Our Ref: 18VM010 RFS Ref: DA09070361165 DC

## Re: Addendum bushfire assessment for approved Torrens Title Subdivision 8 Lady Penryhn Drive, Beacon Hill (Lot 806 DP 752038)

Figure 2 – Proposed plan of subdivision

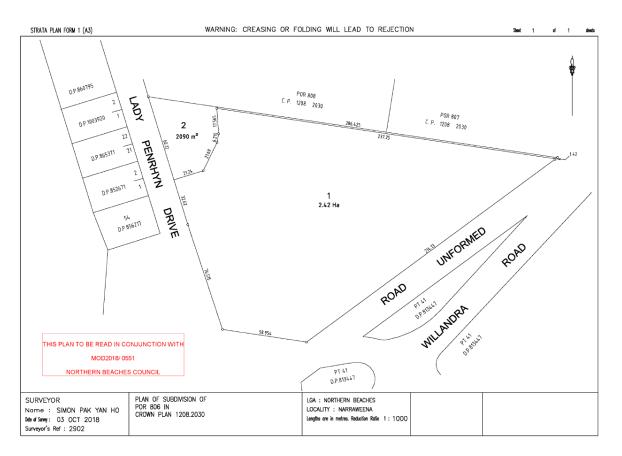
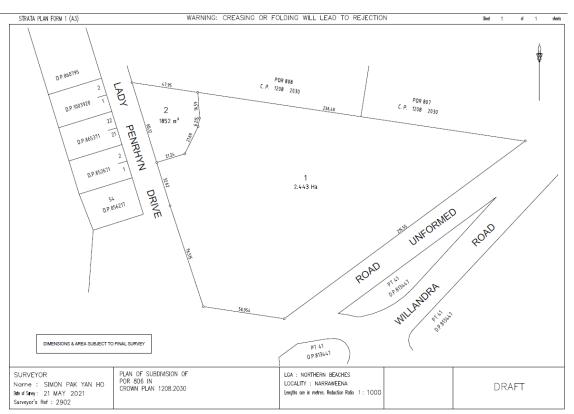
• Adjust the boundary between proposed lot 1 and lot 2 by deleting the 1.42 meters wide strip of land between the two lots.

It is understood the 1.42m strip of land permitted Lot 2 to have the connection by gravity to the sewer pipe on Willandra Road. However upon further consultation with Sydney Water it has been confirmed that an alternative connection is available on Lady Penrhyn Drive.

Please refer Figure 1 & Figure 2 for the proposed minor changes.

*Travers bushfire & ecology* can confirm the proposed amendment to the subdivision boundary will not significantly affect the bushfire safety authority issued the NSW RFS (dated 4<sup>th</sup> February 2010). The changes are minor in nature and will not impact on the conditions relating to asset protection zones, water and utilities, access, evacuation, design and construction or landscaping.
